# Inspection Photos

API: 071-09838

Operator: WAPITI OPERATING LLC

Inspection Date: 3/22/2023

**Photo 6.** Facing east toward the location at the upper cut slope area. Stormwater run-on is causing erosion and is not properly diverted by the perimeter ditch. This area needs to be repaired and stabilized. Previous corrective action is not completed.

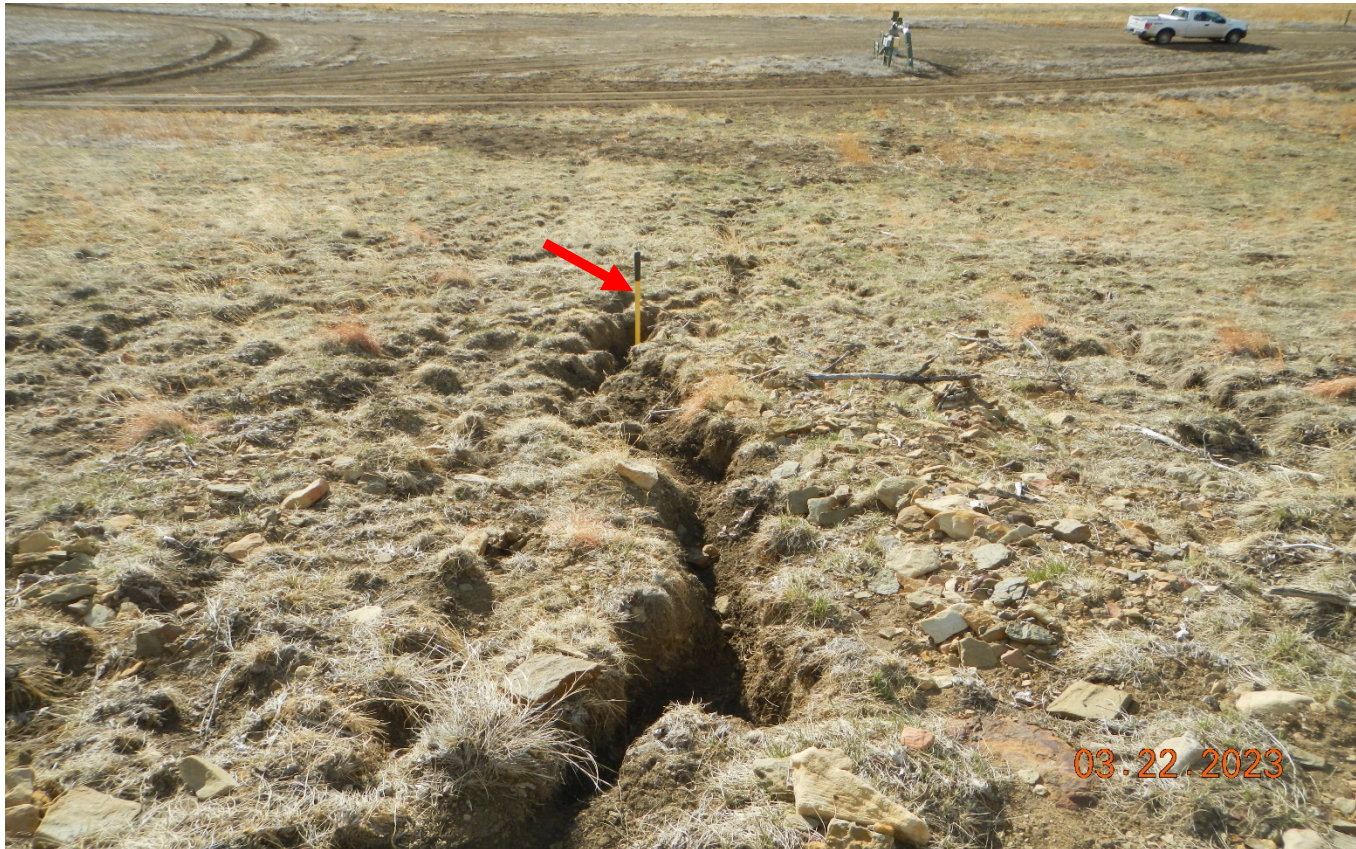
Red arrow points to 4.5 ft. shovel placed in the erosion channel.
